**Development Referral No. DN20/0063**

**Proposal: Environmental Impact Statement (EIS) for alterations and additions to President Private Hospital (SSD-10320).**

**Property: 369-381 President Avenue, Kirrawee**

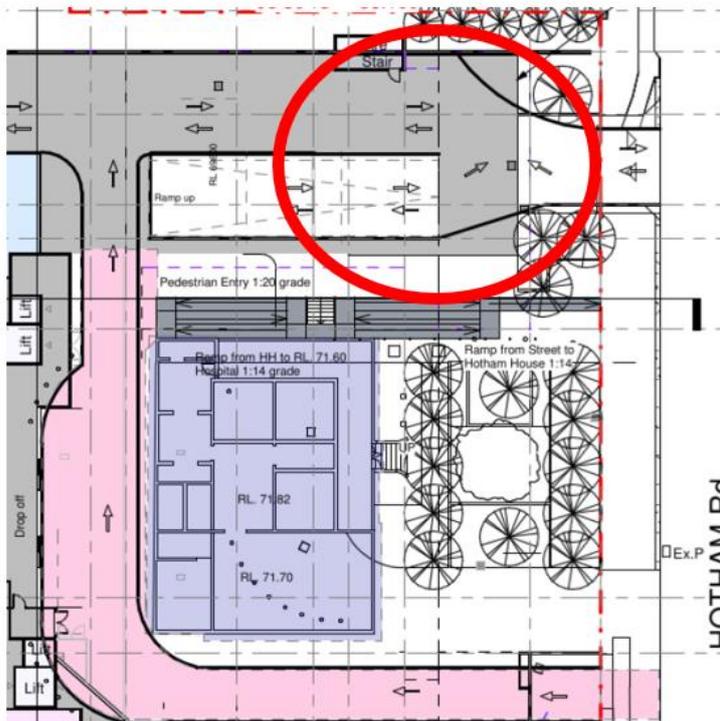
Of most concern is the height of the north wing fronting Hotham Road and to the rear of the existing dual occupancy. This height is excessive in relation to these residential dwellings, particularly 59 Hotham Road which sits much lower than its neighbour at 2A Bidurgal Ave.

Any additional height should be accommodated in the southern portion of the site, where the site drops to President Avenue. There is significant local traffic along President Ave and height impacts can be better ameliorated. The West Wing is only two storey and could potentially accommodate an extra level accessed from the East Wing as per the first floor plan. This area is set back from the residential properties to the north as well as to President Ave.

The removal of height from the eastern section of the North Wing would provide a more appropriate relationship to the low density development to the north.

- Hotham House can be retained with regards to the access points off Hotham Road either utilising the proposed access or as proposed in the Design Options.

- Notwithstanding, it is acknowledged that the internal changes required to support this arrangement would create some challenges with respect to conflicts between service vehicles, port cochere traffic and general traffic entering, and exiting the site at the proposed northern ingress and egress in Hotham Road (as circled in red).
- Both designs as shown in the Retention Report are unsatisfactory and would require a redesign to the northern car park and basement ramp.

- As indicated by the options plan above, a primary pedestrian accessway from the Road to the main entrance / drop of zone (which would now be to the rear of Hotham House) is achievable with a maximum grade of 1:20.
- From the drop off zone to Hotham House requires a single 1:14 ramp.
- In the option plan, the double switchback from Hotham House to the Road could be deleted.
- Signage and other features could clearly provide appropriate way finding to this entrance from the street.
